30-039-23193 JICARILLA 362 GD #002

DJR OPERATING, LLC

Re: Permanent Abandonment
Well: Jicarilla 362 GD 2

Plug And Abandonment Procedure

Wellbore Diagram

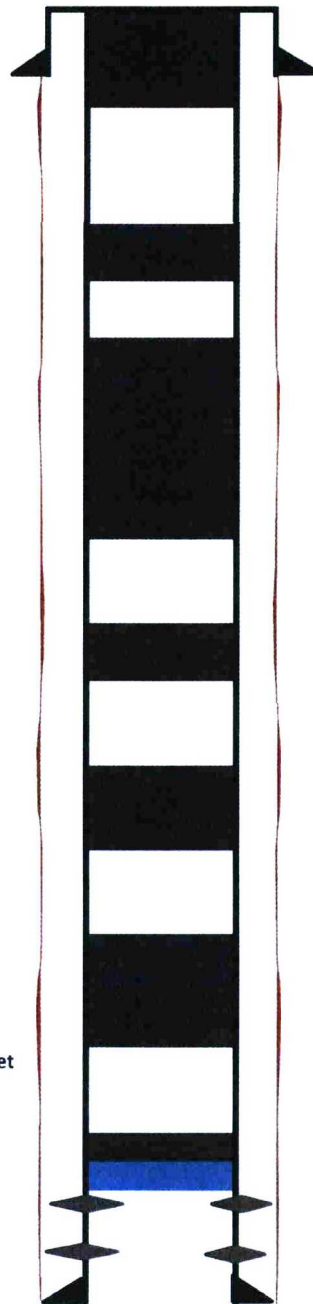
- Notify NMOCD 24hrs prior to beginning operations.
- Add additional plug 5,870' - 5,770' to cover the Gallup top. OCD Gallup pick @ 5,820'.
- Extend plug #5 to 2,195' - 1,870' to cover the Ojo Alamo top. OCD Ojo Alamo pick @ 2,145'.
- Add additional plug 1,020' - 920' to cover the Nacimiento top. OCD Nacimiento pick @ 970'.

1. Plugging operations authorized are subject to the attached "General Requirements for Permanent Abandonment of Wells on Federal and Indian Lease."
2. Farmington Office is to be notified at least 24 hours before the plugging operations commence (505) 564-7750.
3. Submit electronic copy of the CBL for verification to the following addresses: jkillins@blm.gov , jhoffman@blm.gov and Brandon.Powell@state.nm.us . Based on CBL results inside/outside plugs and volumes will be adjusted accordingly. Please review the General Requirements document to ensure volumes meet required excess inside and outside casing.
4. Modify plug 5: BLM picks top of Ojo Alamo 1870' md. Add to plug 5 or add an additional plug to cover entire Ojo Alamo (1870'-2130' md)
5. Modify plug 6: BLM picks top of Nacimiento 650' md. Adjust plug to cover (600' – 700' md)
